Approval no: DEV2023/1446

TRANSPORT ASSESSMENT

PROPOSED WAREHOUSE DEVELOPMENT

PROPOSED LOT 101 FLAGSTONE LOGISTICS
ESTATE, NORTH MACLEAN

FIGURE 4.7 – PROPOSED CAR PARKING LAYOUT AND DIMENSIONS

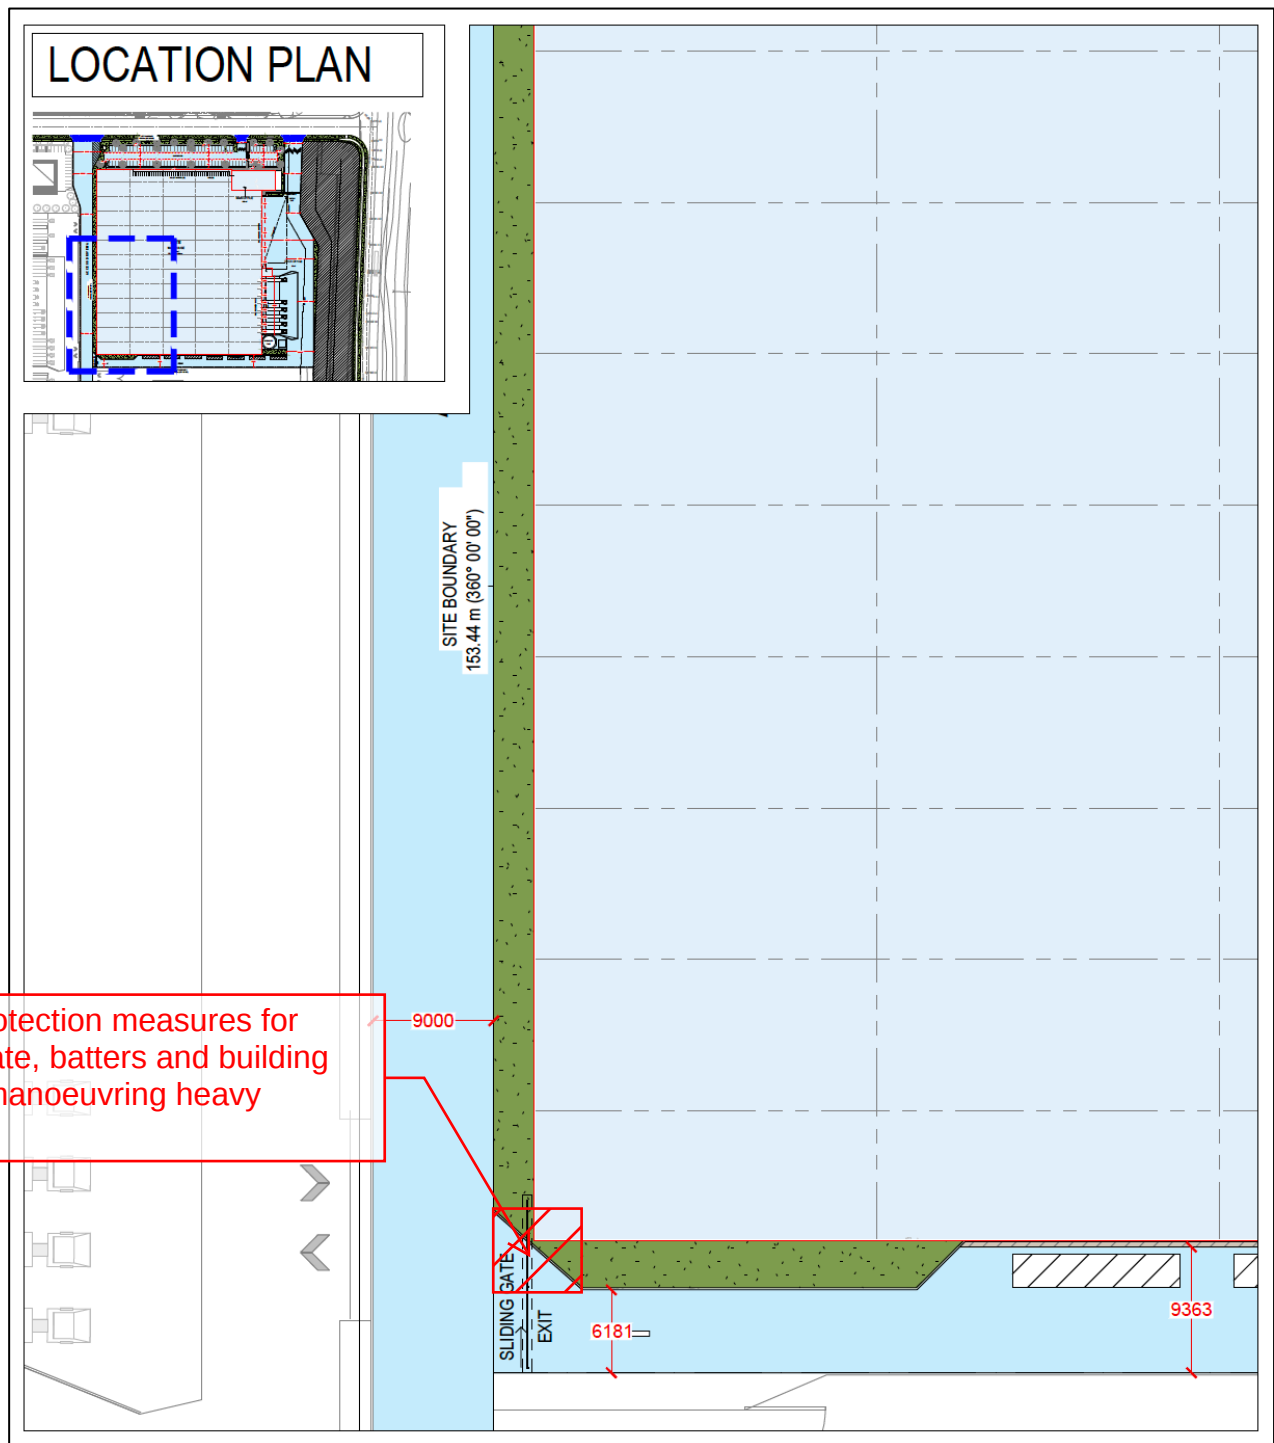
AMENDED IN RED
